Mindel House. Upper floors

LAYOUT REVISED TO IMPROVE LIVING SPACE
EXPOSED COLUMNS AND CAPITALS
- PICADILLY WAREHOUSE | PLANNING PRESENTATION 39

Bloom Street. First and Second Floor

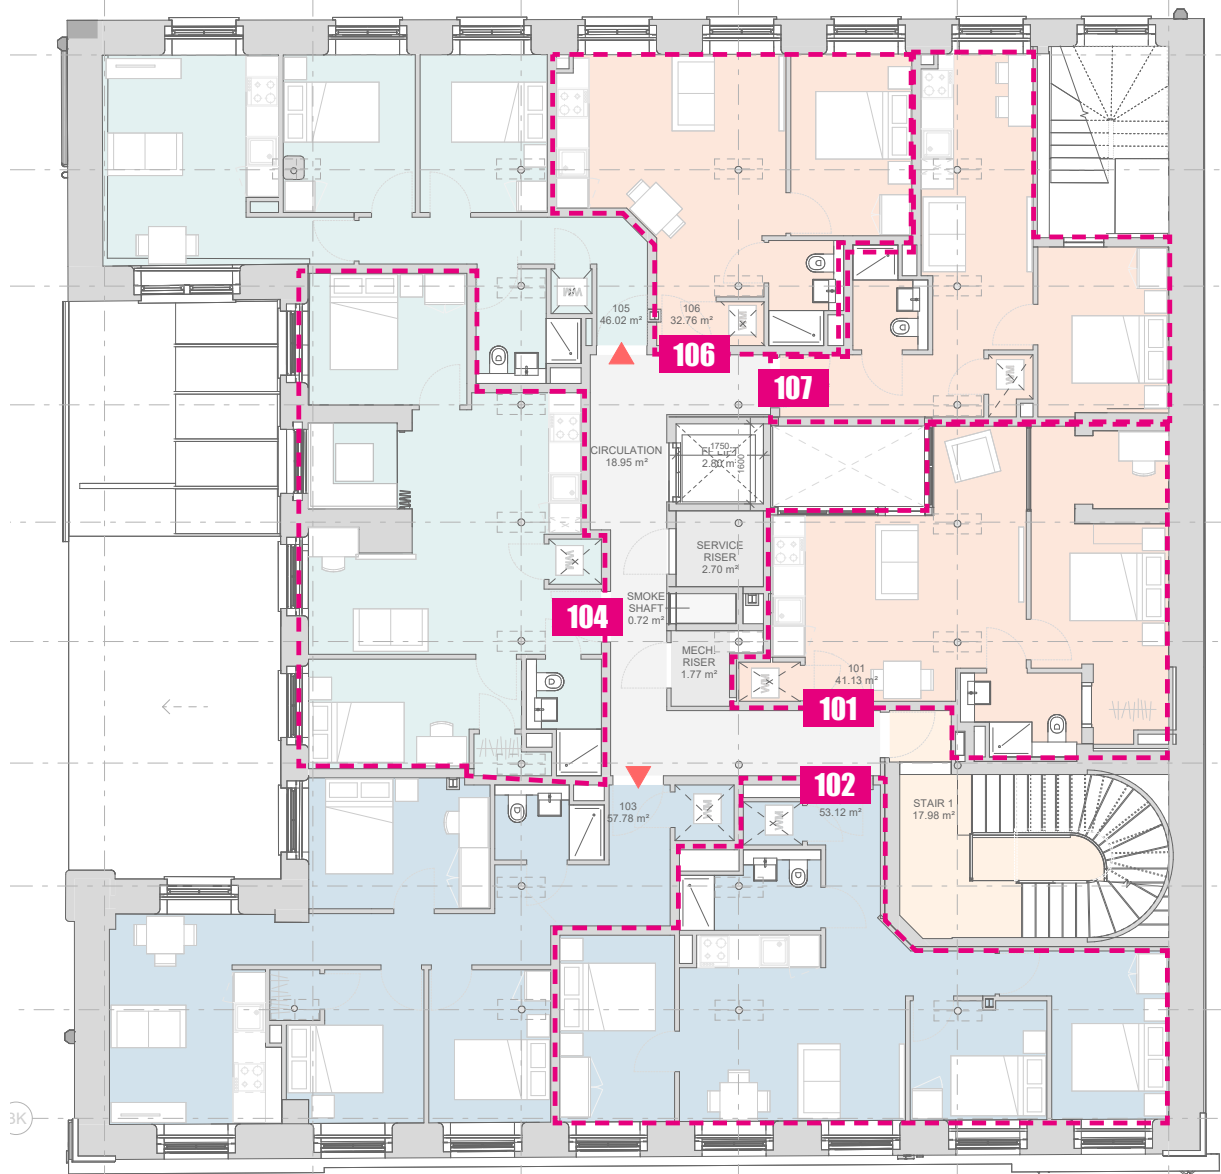
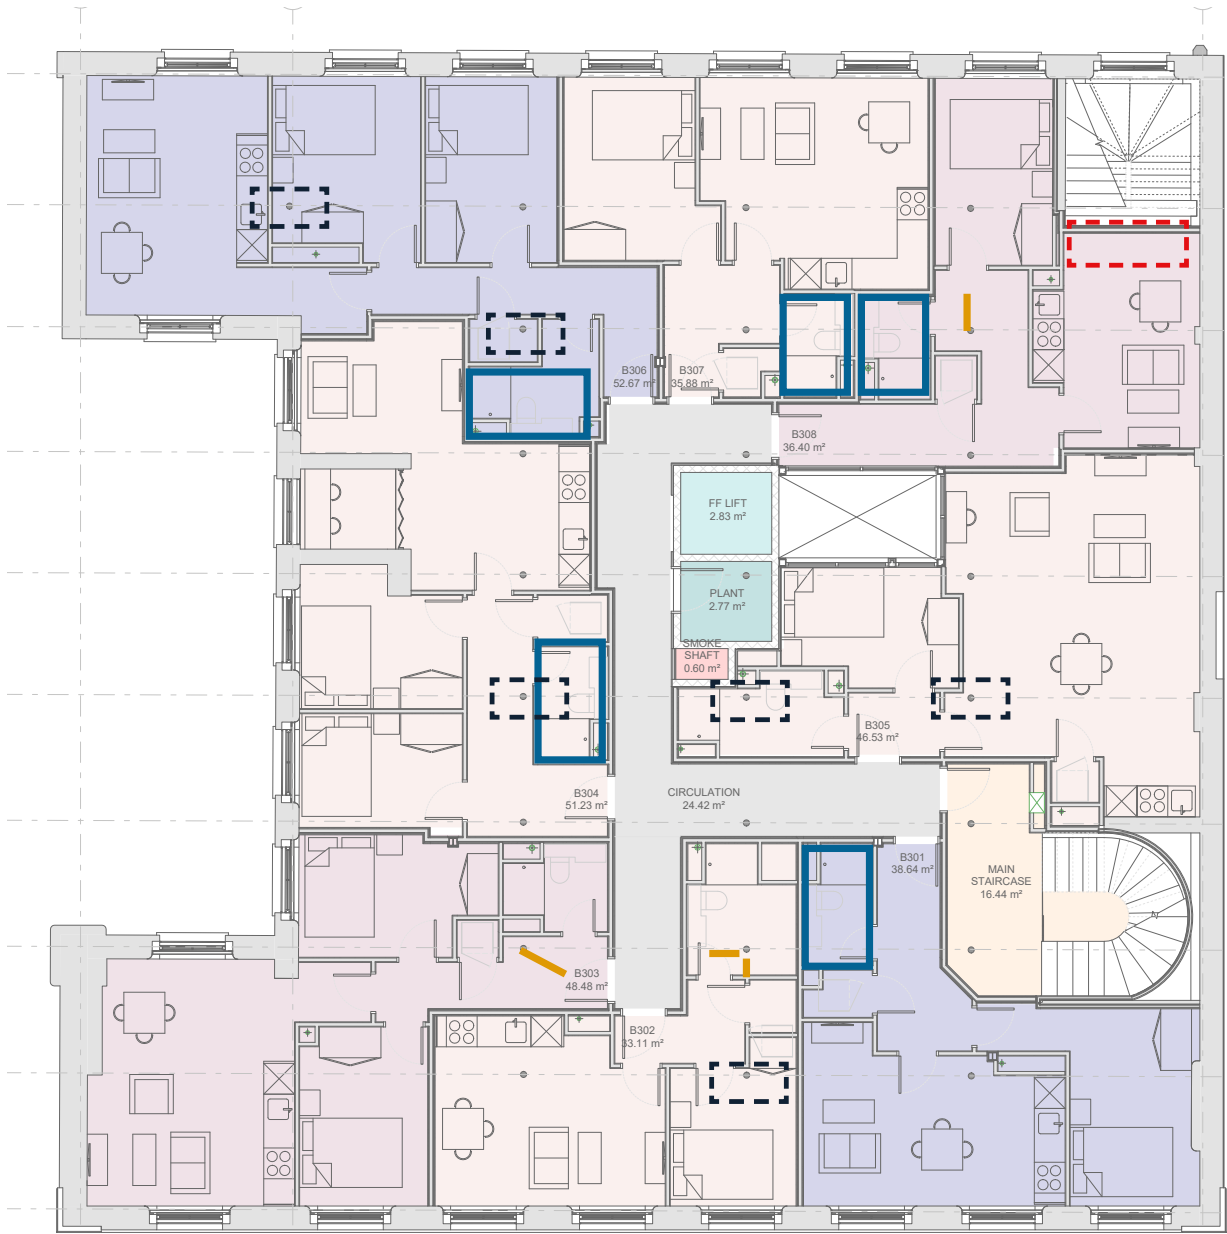
Clear width non compliant (less than 850mm)

Bathroom non compliant (typically too narrow)

Column capital clashing with wall

Missing Landing

Layout Change

OPEN PLAN ARRANGEMENT
IMPROVED KITCHEN/LIVING NATURAL LIGHT
OPTIMIZED LAYOUT
EXPOSED COLUMNS AND CAPITALS

OPEN PLAN ARRANGEMENT
INVERTED KITCHEN/LIVING WITH BEDROOM LOCATION

OPEN PLAN ARRANGEMENT
INVERTED KITCHEN/LIVING WITH BEDROOM LOCATION

OPEN PLAN ARRANGEMENT
INVERTED KITCHEN/LIVING WITH BEDROOM LOCATION

OPEN PLAN ARRANGEMENT
INVERTED LIVING WITH BEDROOM LOCATION
EXPOSED COLUMNS AND CAPITALS

Bloom Street. Third and Fourth floor

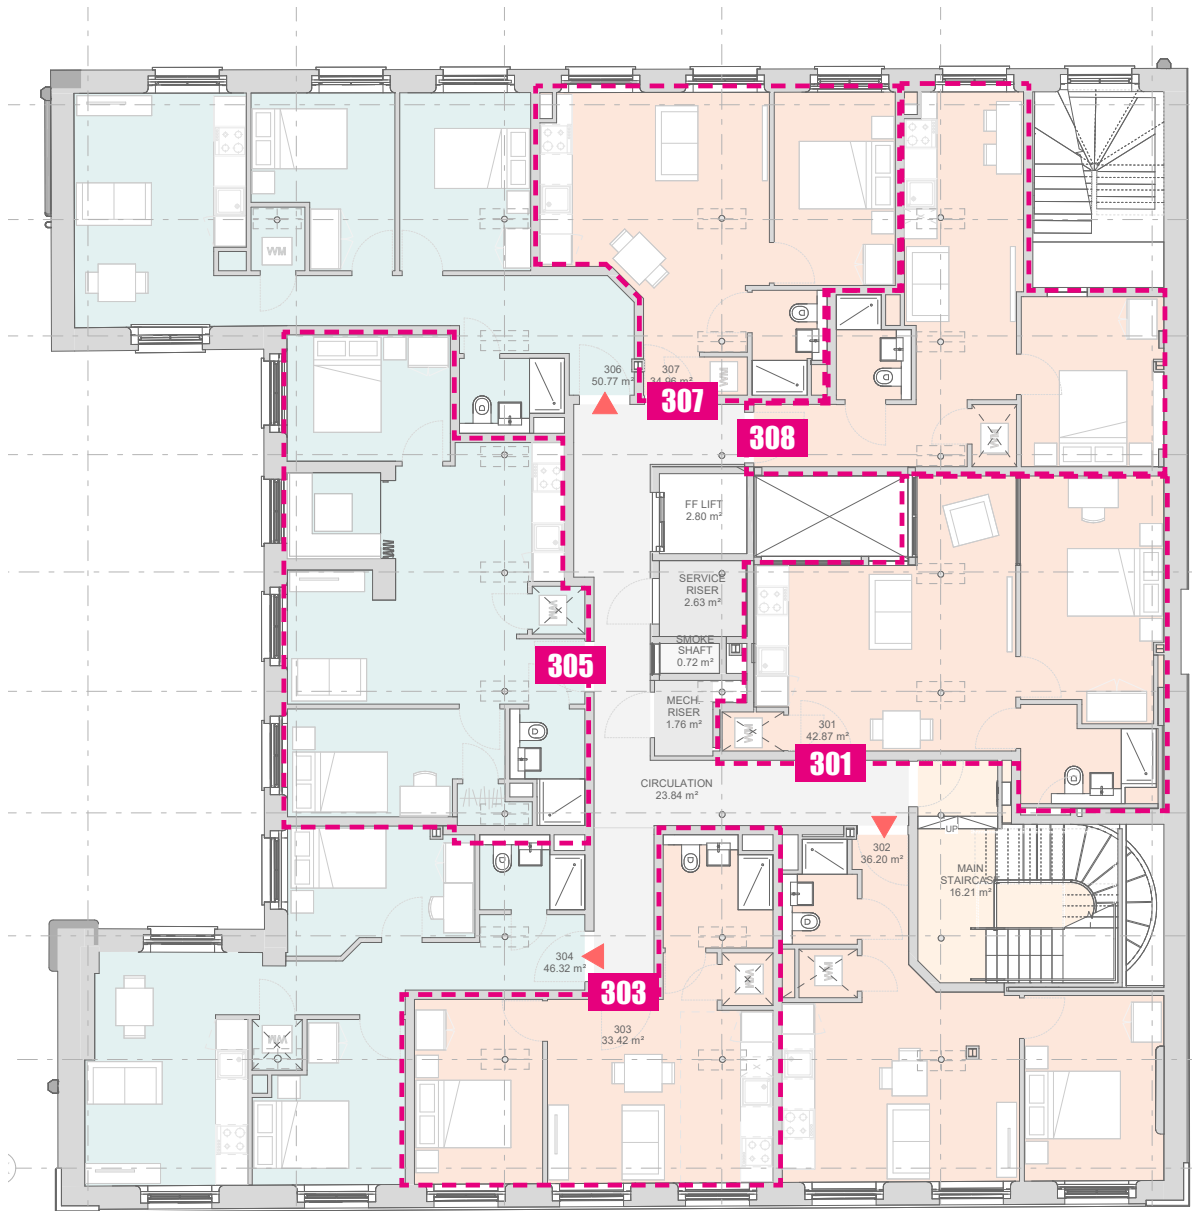
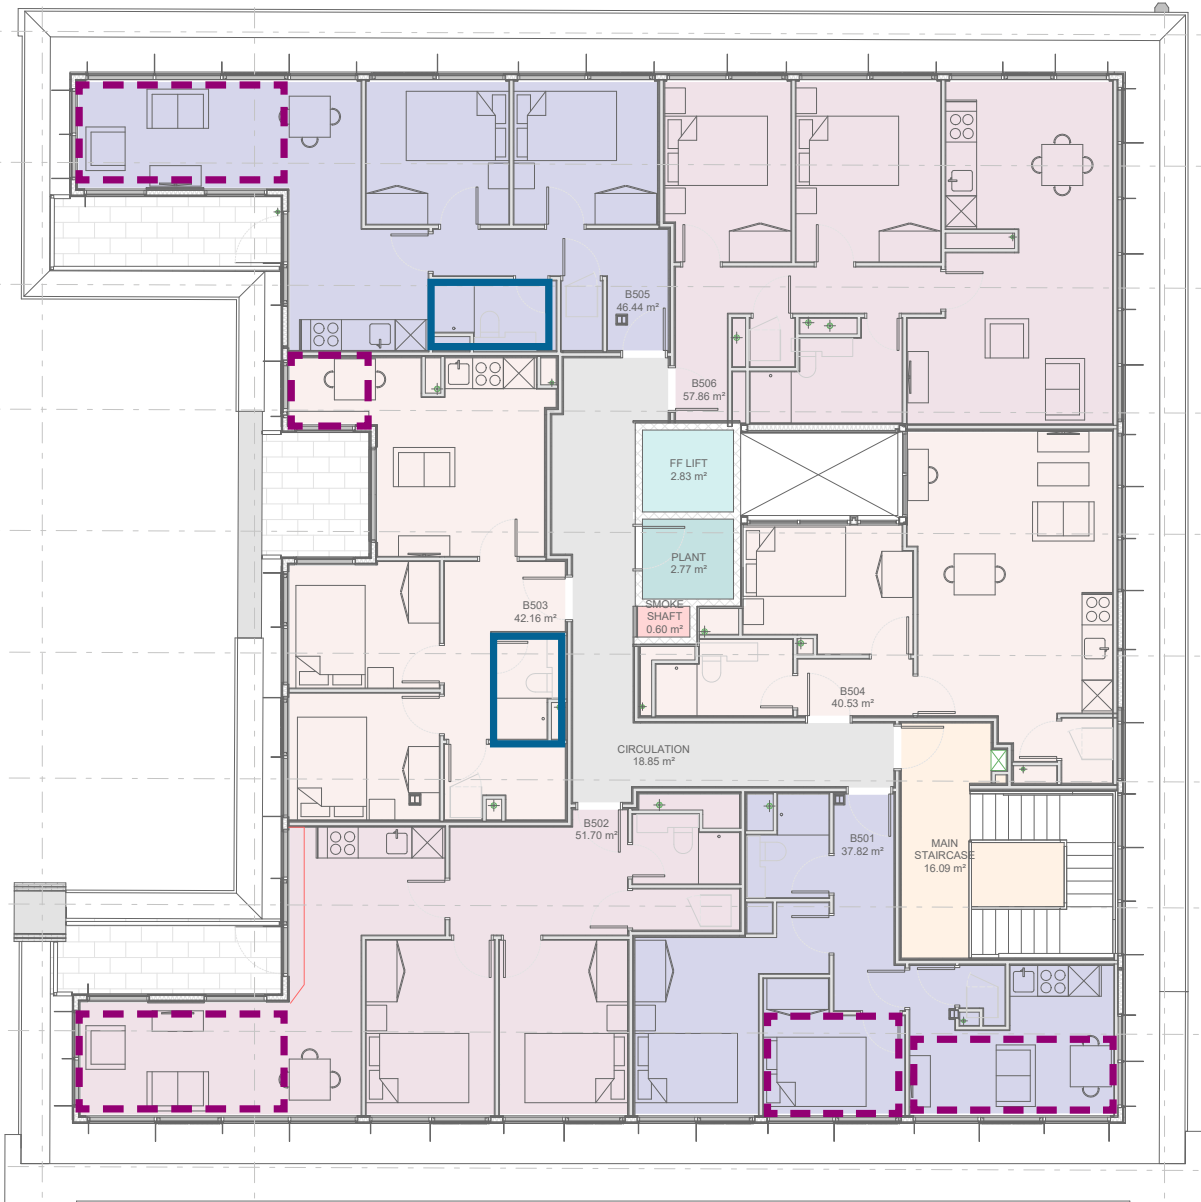
Clear width non compliant (less than 850mm)

Bathroom non compliant (typically too narrow)

Column capital clashing with wall (Level 3 only)

Missing Landing

Layout Change

OPEN PLAN ARRANGEMENT
IMPROVED KITCHEN/LIVING NATURAL LIGHT
OPTIMIZED LAYOUT
EXPOSED COLUMNS AND CAPITALS

OPEN PLAN ARRANGEMENT
INVERTED KITCHEN/LIVING WITH BEDROOM LOCATION

OPEN PLAN ARRANGEMENT
INVERTED KITCHEN/LIVING WITH BEDROOM LOCATION

OPEN PLAN ARRANGEMENT
INVERTED KITCHEN/LIVING WITH BEDROOM LOCATION
EXPOSED COLUMNS AND CAPITALS

OPEN PLAN ARRANGEMENT
INVERTED LIVING WITH BEDROOM LOCATION
EXPOSED COLUMNS AND CAPITALS

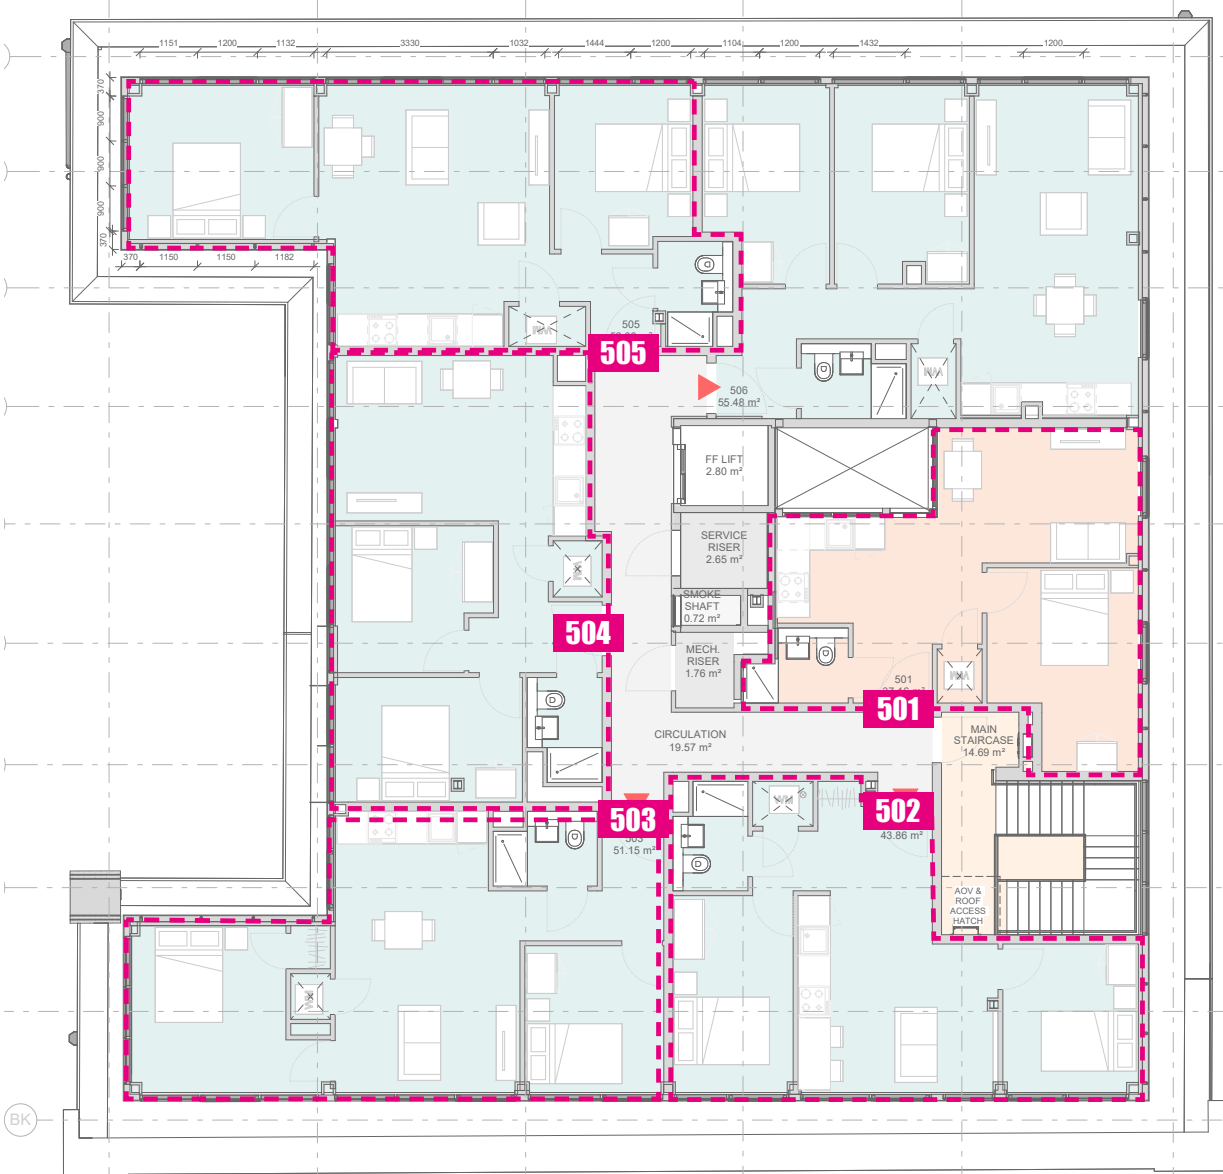
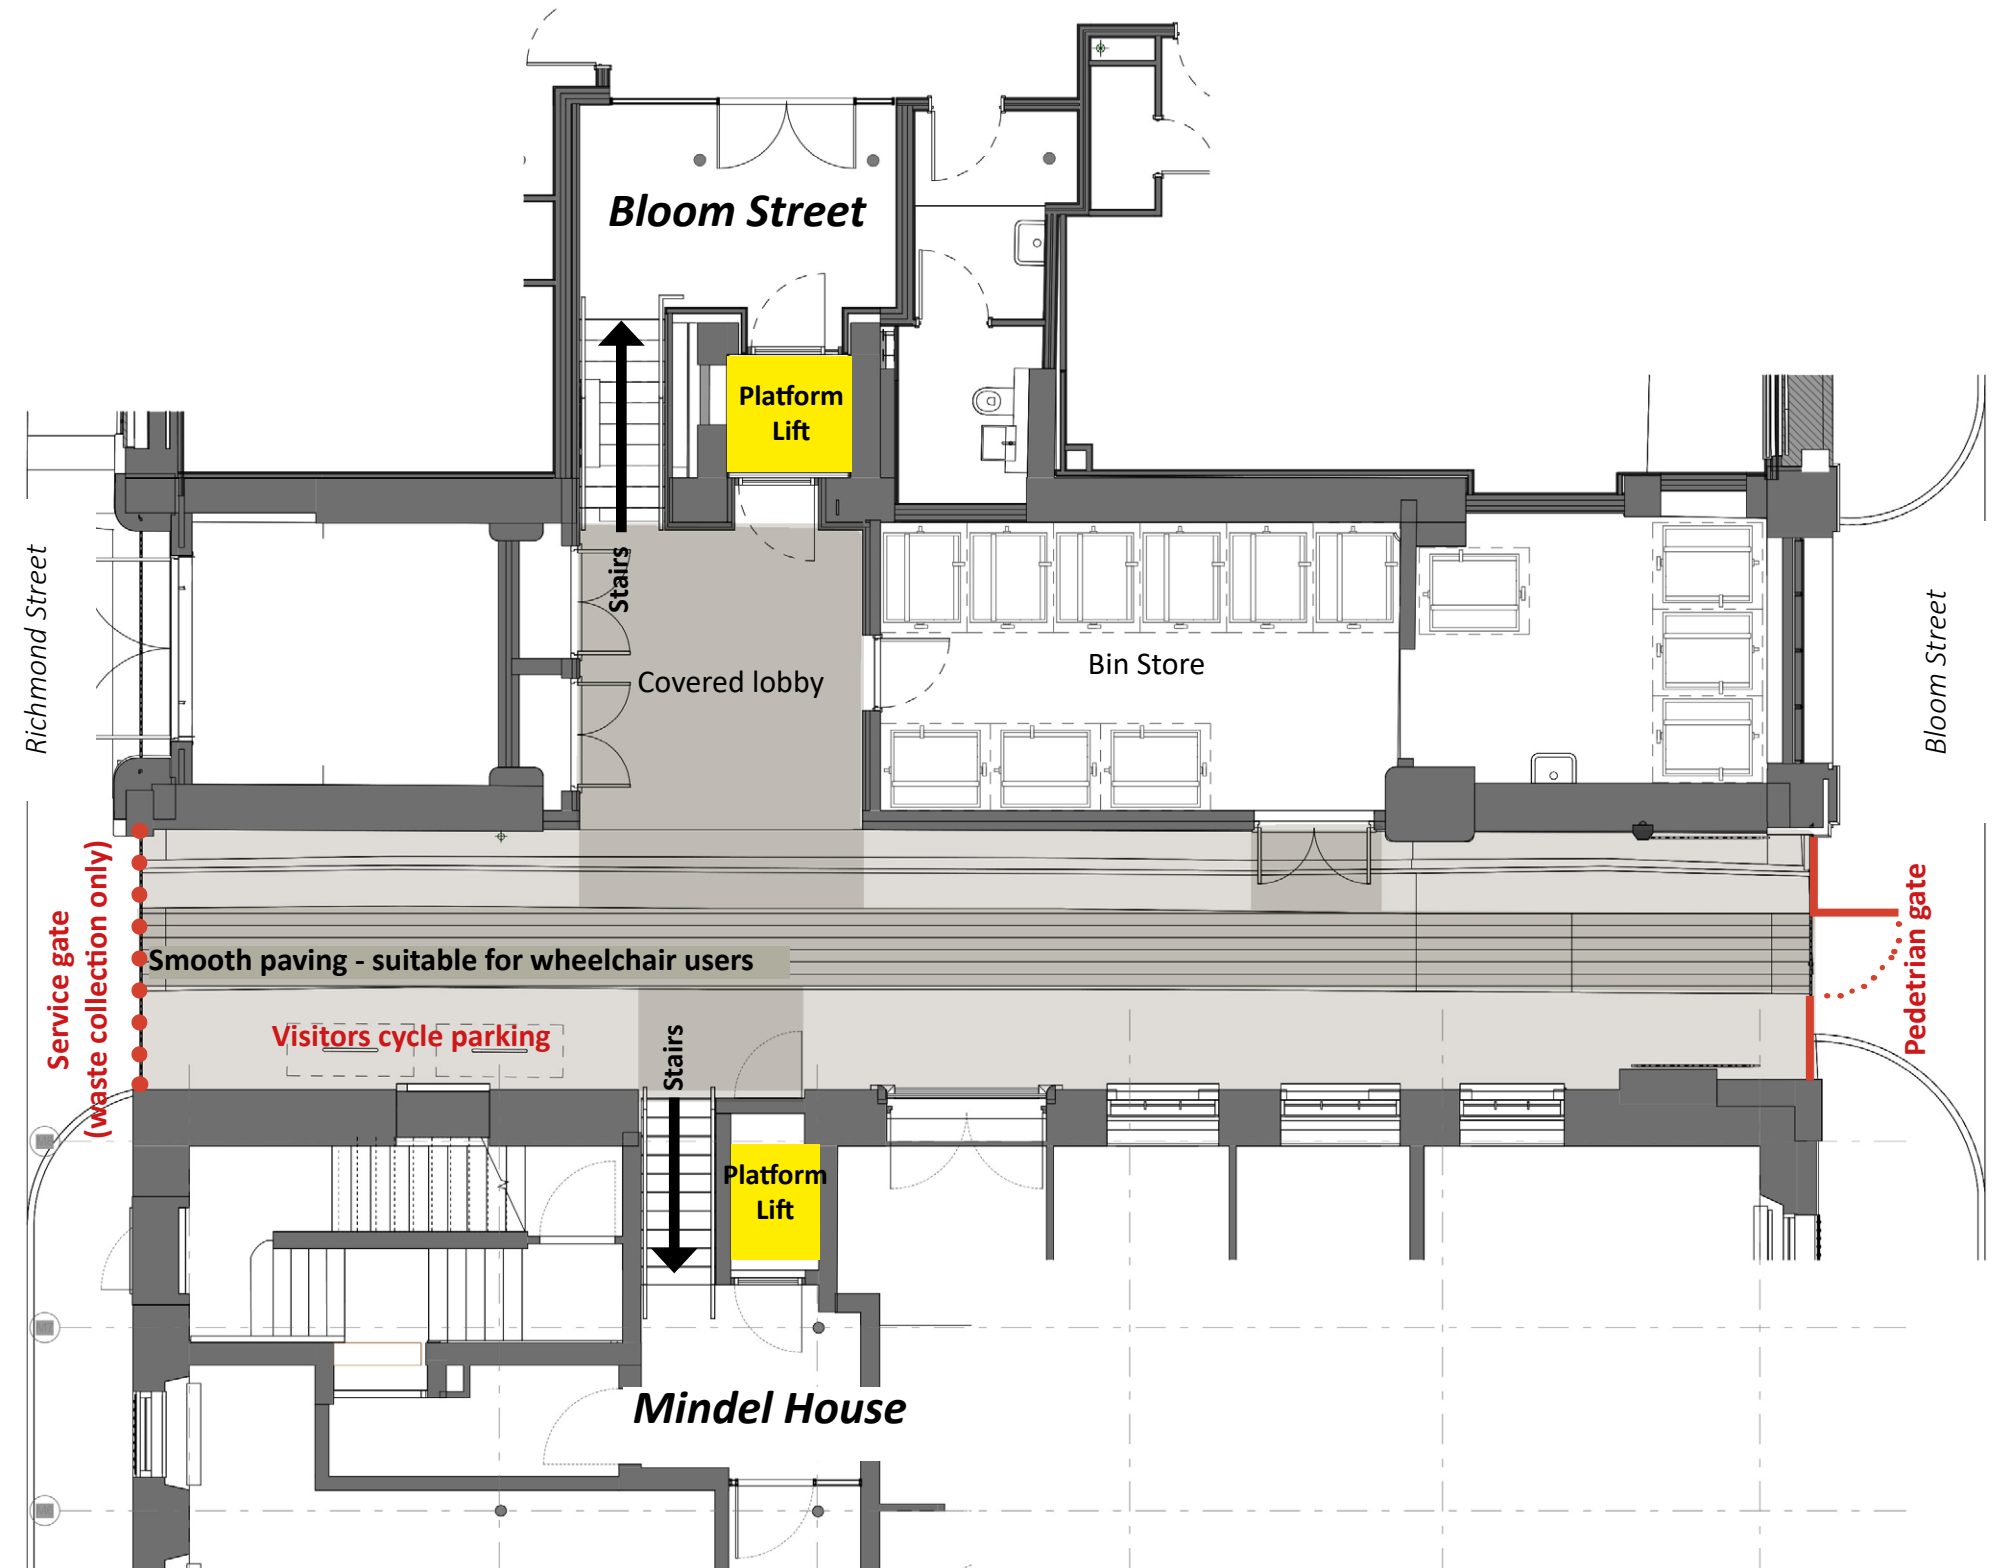
- Clear width non compliant (less than 850mm)
- Bathroom non compliant (typically too narrow)
- Column capital clashing with wall
- Area too narrow
- Layout Change

- 501 OPEN PLAN ARRANGEMENT
INVERTED KITCHEN/LIVING WITH BEDROOM LOCATION
- 502 OPEN PLAN ARRANGEMENT
INVERTED KITCHEN/LIVING WITH BEDROOM LOCATION
NARROW LIVING SPACE RECONFIGURED
- 503 OPEN PLAN ARRANGEMENT
INVERTED KITCHEN WITH BEDROOM LOCATION
- 505 BALCONY REMOVED
NARROW LIVING SPACE REDESIGNED
LAYOUT ADJUSTED TO GIVE MORE SPACE TO APT.502 (503 ONLY)
- 504 BALCONY REMOVED TO PROVIDE BETTER INTERNAL LIVING SPACE
